**APPLICATION REVIEW FOR
LOW IMPACT HYDROPOWER INSTITUTE CERTIFICATION
of the
GREEN MOUNTAIN POWER
ESSEX 19 HYDROPOWER PROJECT NO. P-2513**

REVIEW OF APPLICATION FOR CERTIFICATION BY THE LOW IMPACT HYDROPOWER INSTITUTE OF THE ESSEX 19 HYDROPOWER PROJECT

Prepared by: Patricia McIlvaine, April 1, 2017

Updated and revised November 6, 2018, Maryalice Fischer

concrete weir view from the upstream plunge pool

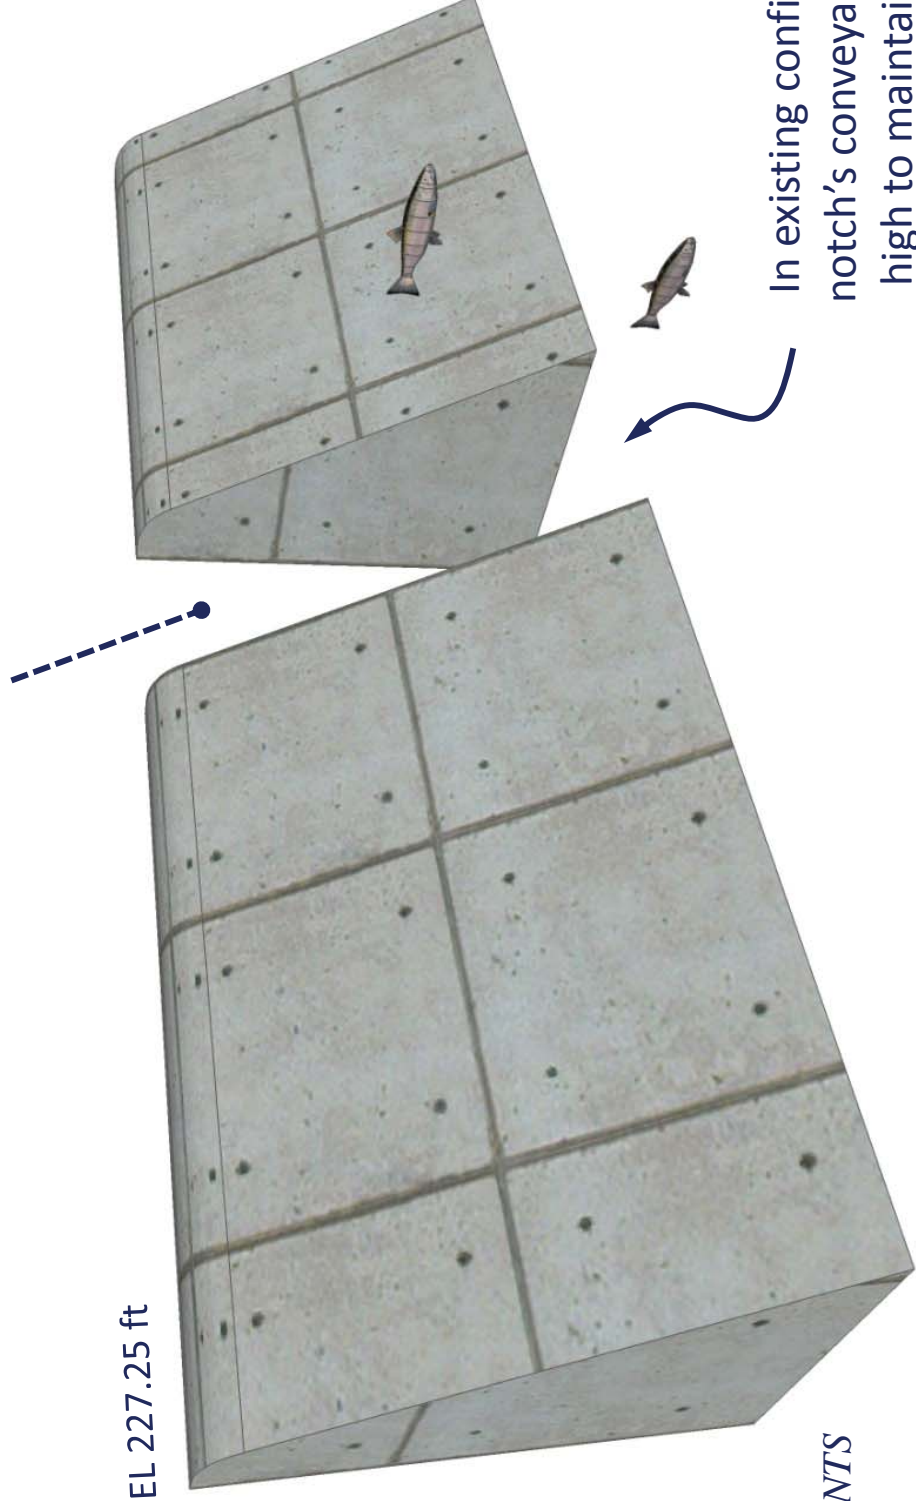
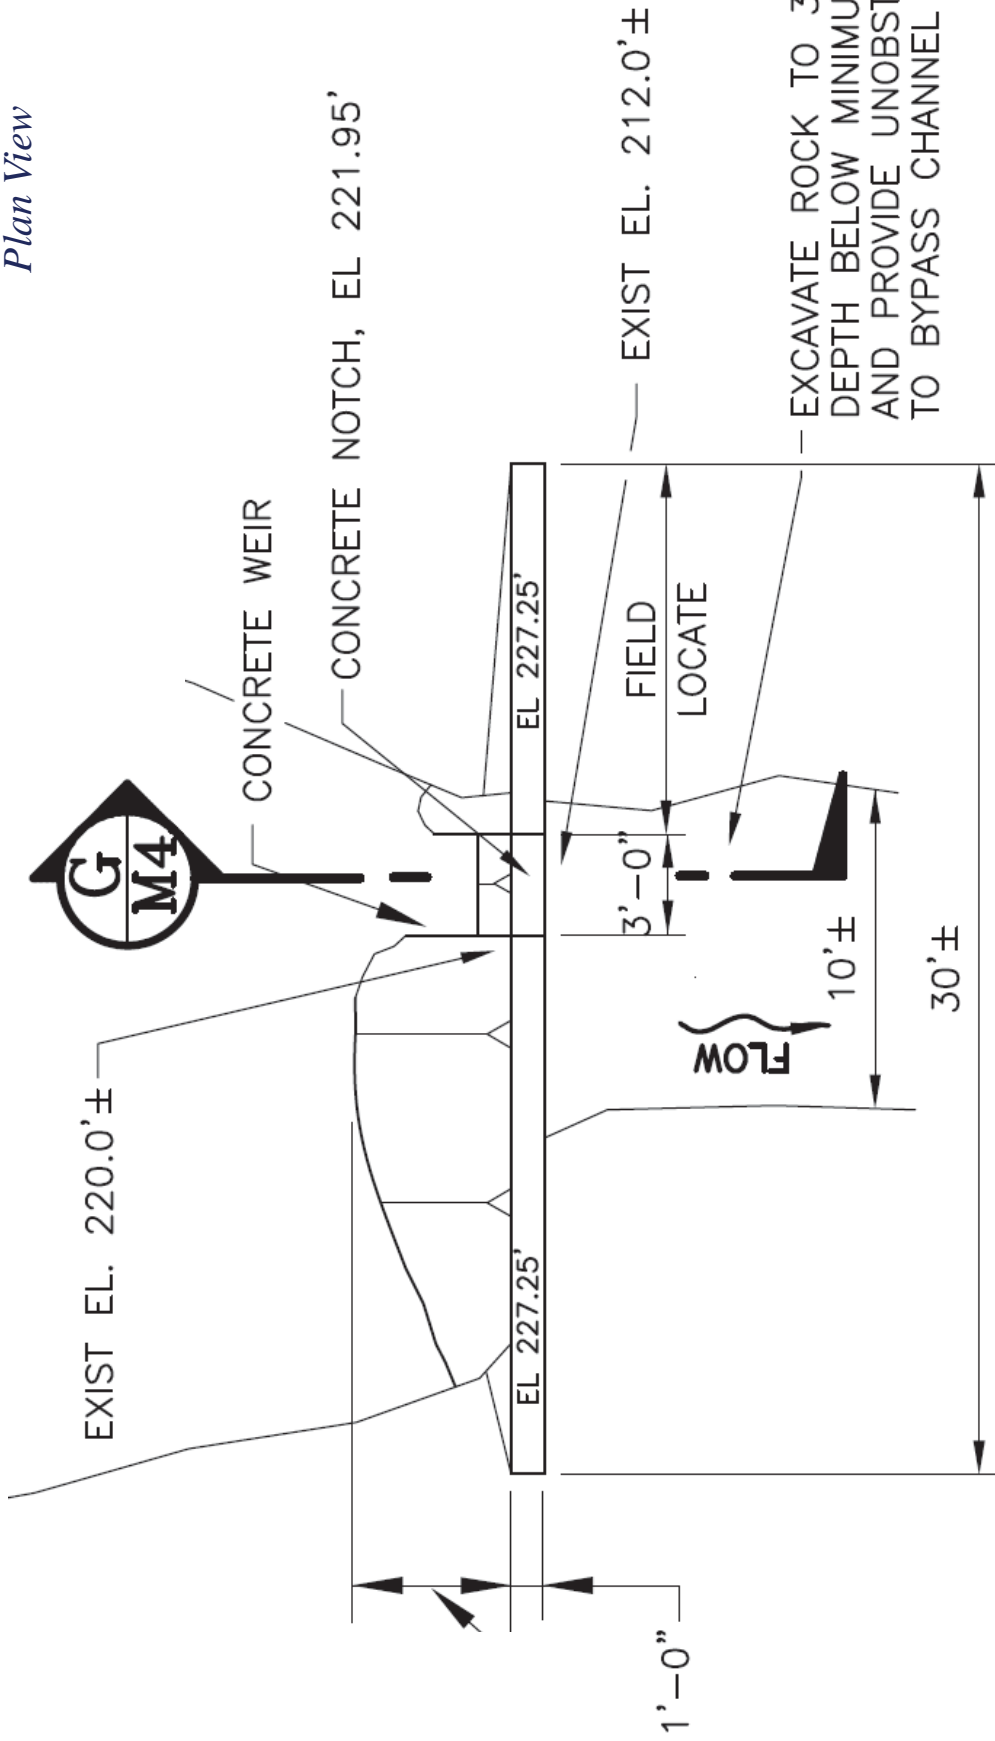
notch is 3 feet wide and
5.3 feet high (from sill to T.O.W.)

In existing configuration,
notch's conveyance is too
high to maintain plunge
pool at T.O.W.

from Record Drawing D-4, 012-034-003 Kleinschmidt Assoc., 2/14/1995

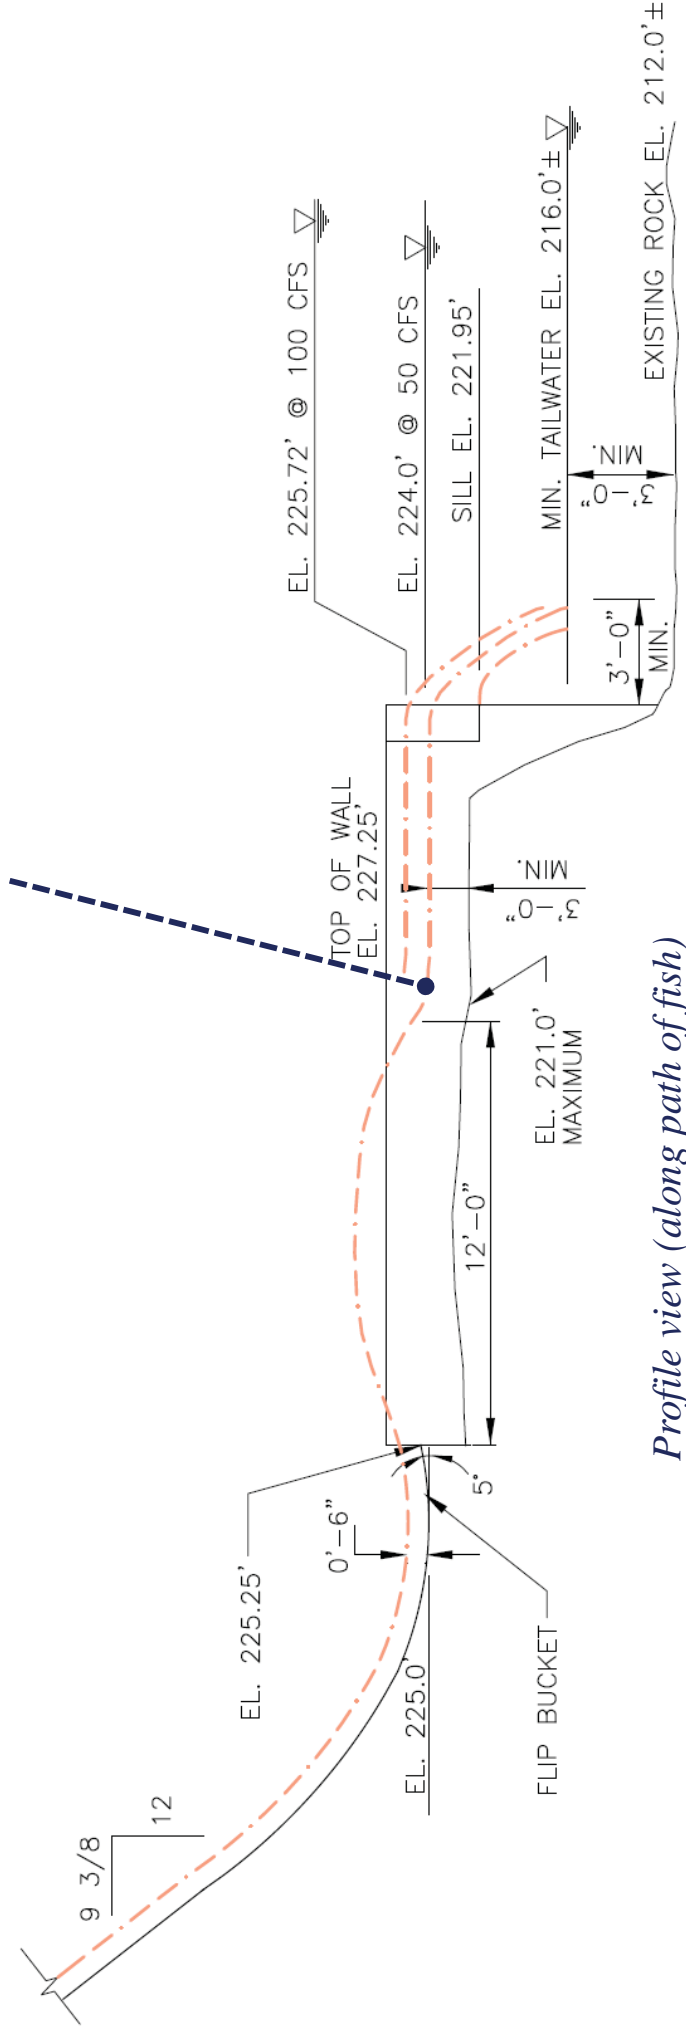
Original plunge pool design called for a 3 foot deep pool. This is not consistent with current Service recommendations, see USFWS (2017) "Fish Passage Engineering Design Criteria" and, based on observations, a 3-foot-deep pool is insufficient to dampen the momentum in the jet exiting the bypass chute (at flip bucket) leading to jet impact against rock outcroppings on the southeast side of the plunge pool.

- Concrete weir and notch from the downstream side
- Notch is blocked with boards to facilitate testing
 - No flow through the DS bypass

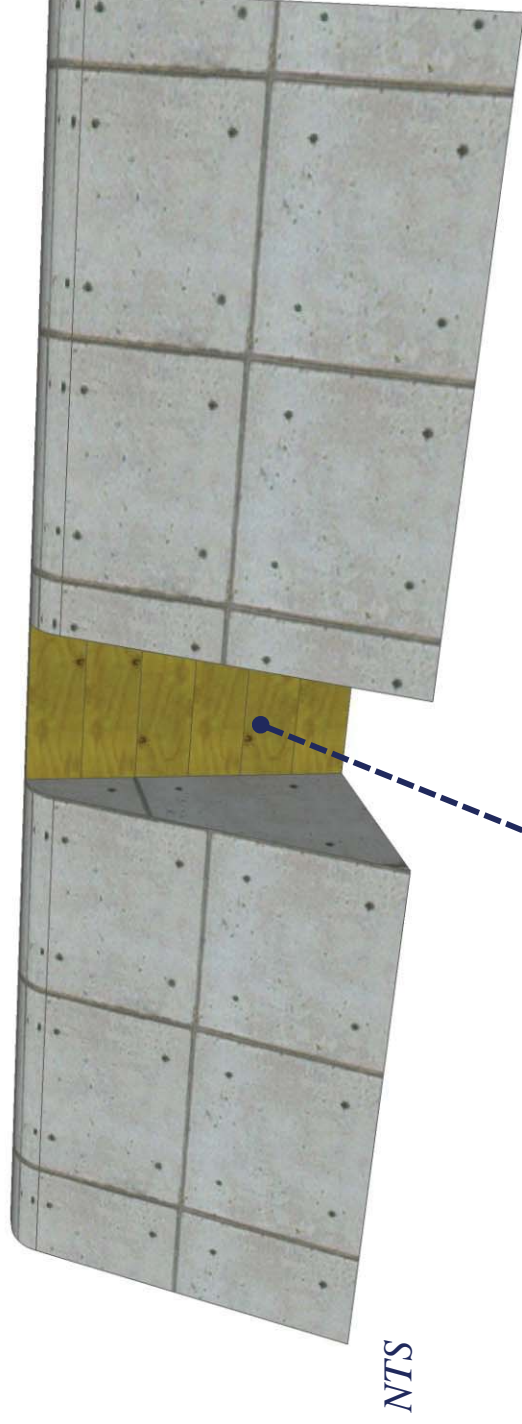
On 8/22/2017, the Service and state agencies participated in a test with GMP and KA to determine if raising the water level would diminish the impact of the downstream bypass jet and enhance passage. Results of the hydraulic test (nominally at 100 cfs) and an evaluation of injury potential using a surrogate suggested that passage is enhanced if the plunge pool is maintained at the T.O.W. elevation of 227.25 ft.

During testing, the pool was maintained by completely blocking the concrete notch with wooden boards. This is not a workable long-term fix because (as testing revealed) the increased height introduces additional injury hazard at the fall into the lower pool (downstream of the plunge pool). A long term fix must release less water but do so well below the T.O.W.

Recommended Permanent Solution: Bell-mouthed Vertical Slot Steel Insert

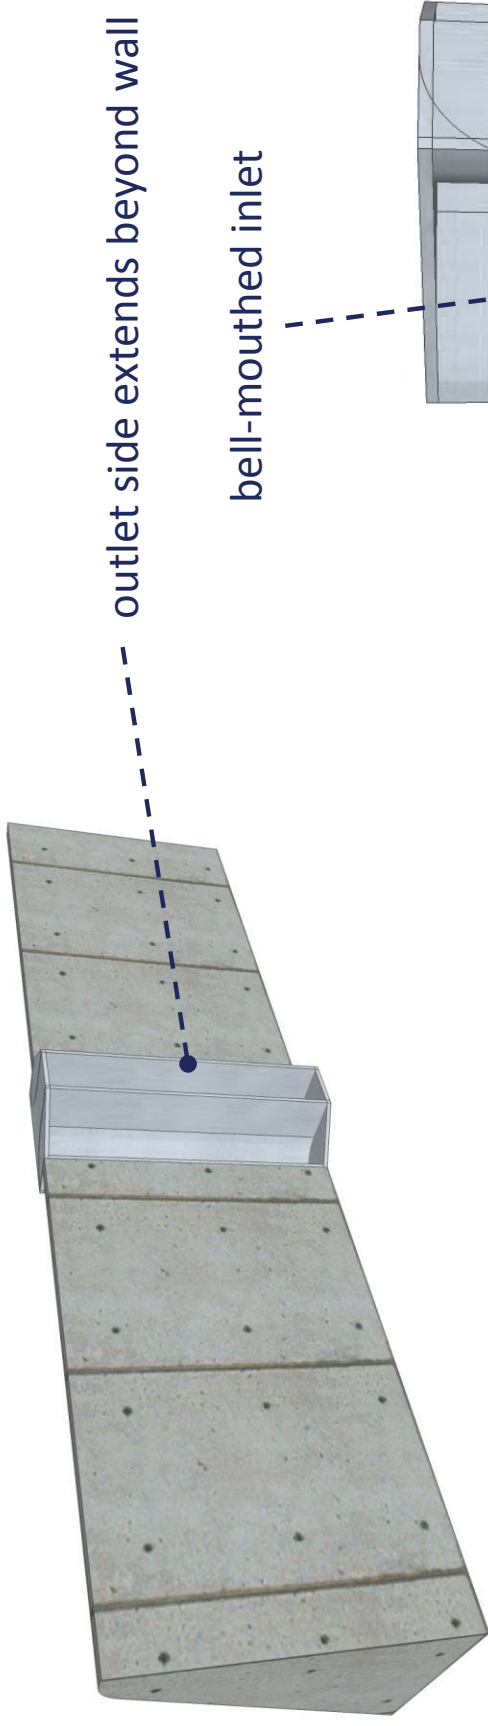
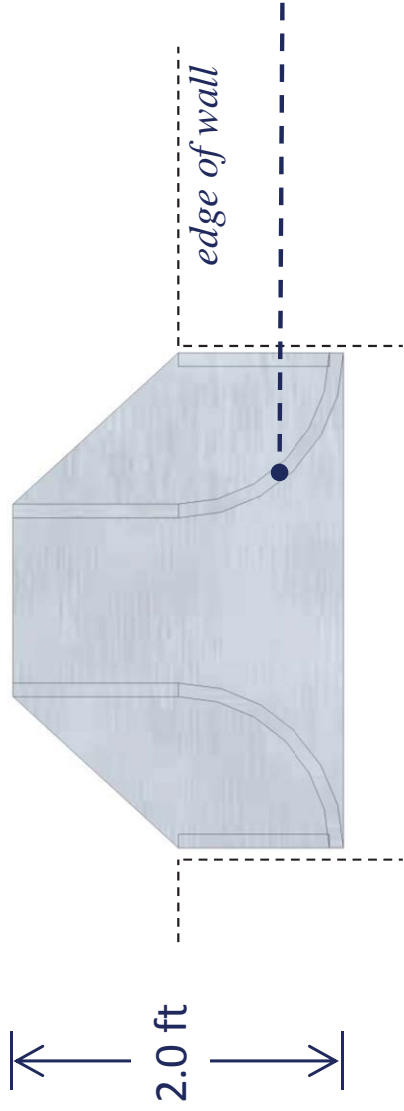
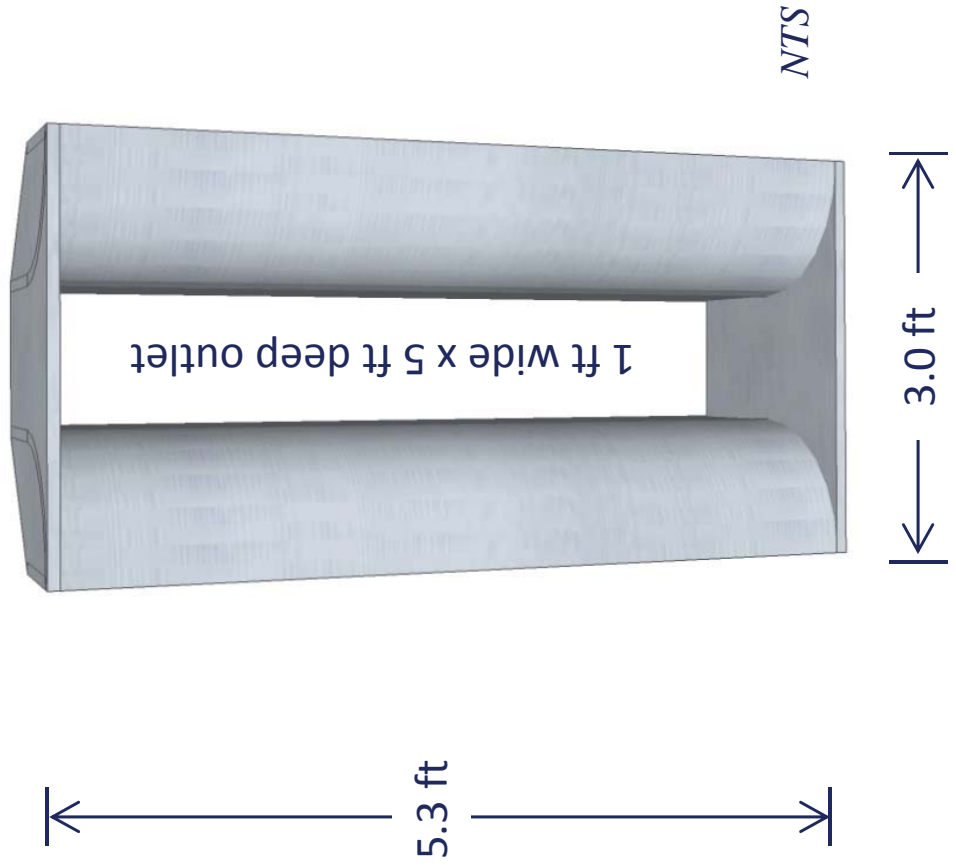
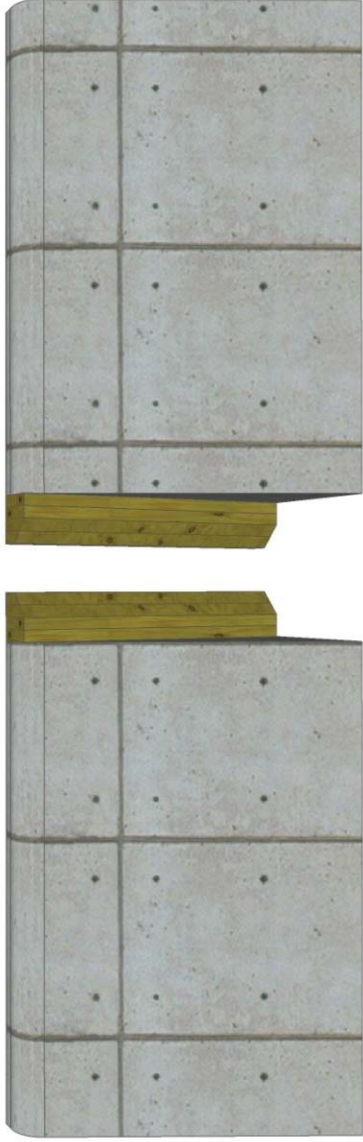
- 3 ft wide, 5.3 ft tall insert for concrete notch
- welded steel construction for year-round installation
- provides DS passage through full depth of water column
- restricts conveyance through notch, thereby backwatering plunge pool to 227.25 ft when 100 cfs is passed through bypass
- 1.0 foot wide opening suitable for salmon and smaller species
- bell-mouthed at inlet borrows from “uniform acceleration weir” concept; designed to eliminate rapid water accelerations created by sharp corners that lead to rejection behavior in DS migrating smolts
- Outlet side of insert extends 1.0” feet downstream of wall to train jet and ensure that water (and fish) do not impact bedrock below concrete wall

outlet side extends beyond wall to train flow over bedrock

bell-mouth edges with radius of bend approximately 1.0 ft

Steel insert could be attached to concrete wall via epoxied anchors

Outlet collects from the entire water column allow fish to escape plunge pool at depth (similar to original notch design)

Restricting the sides works to reduce conveyance and maintains backwatering in the plunge pool

Hydrodynamic shape projects nappe into lower pool (keeping water and fish off bedrock wall)

Recommended Temporary Solution:
Alternative 1

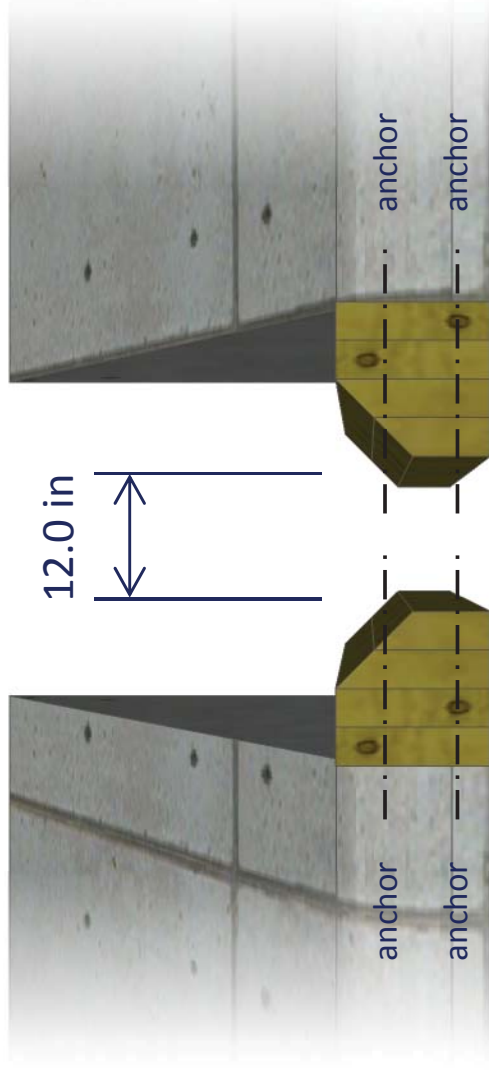
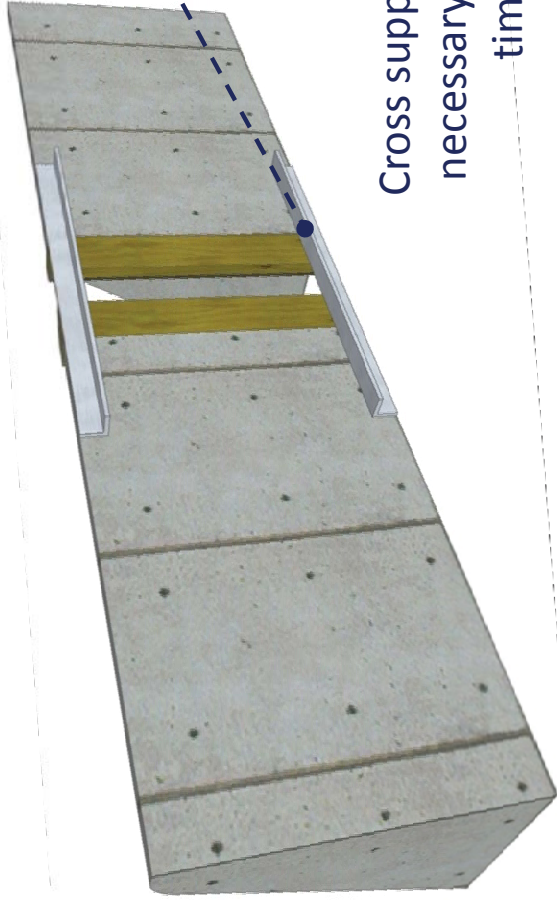
Mitered timbers

Built from a single rough cut 9" x 12" timber or composite of 4 rough cut 3" x 9"

Timbers are attached to the side walls of the notch using wedge anchors or epoxied anchors
